Week 5 Meeting

2/14/19

Topics

Communication Outside

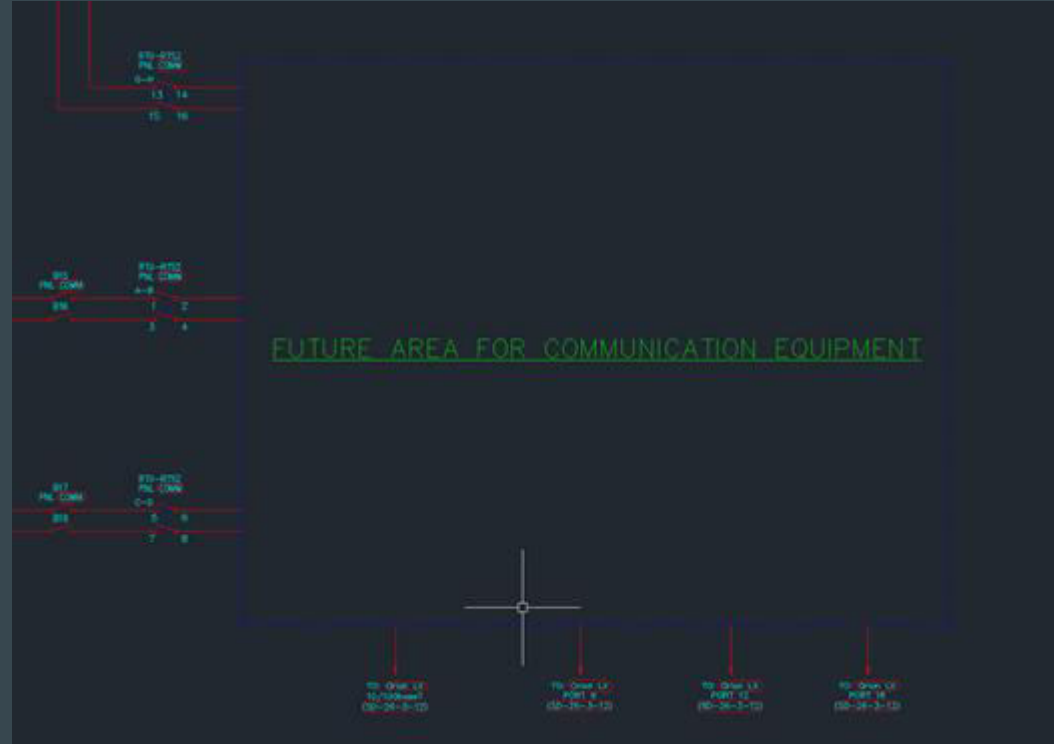
As we noticed, comm outside drawing is just connected to comm rtu drawing but what's the purpose of the blue box? Do we have to remove it?

Communication RTU

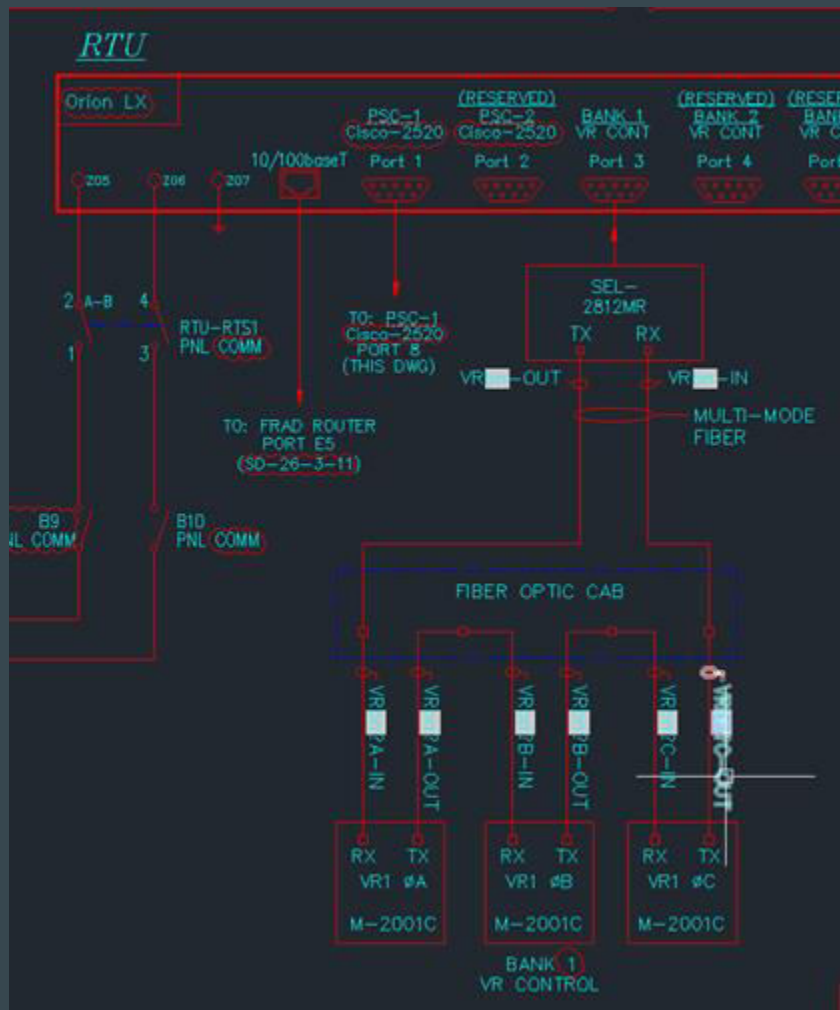
What is SEL-2812MR?

1. For the Communication RTL drawing, what documents do we refer to? Because the project scope diagram is very brief and general but there's a lot more ports and stuffs inside the actual autocad drawing.
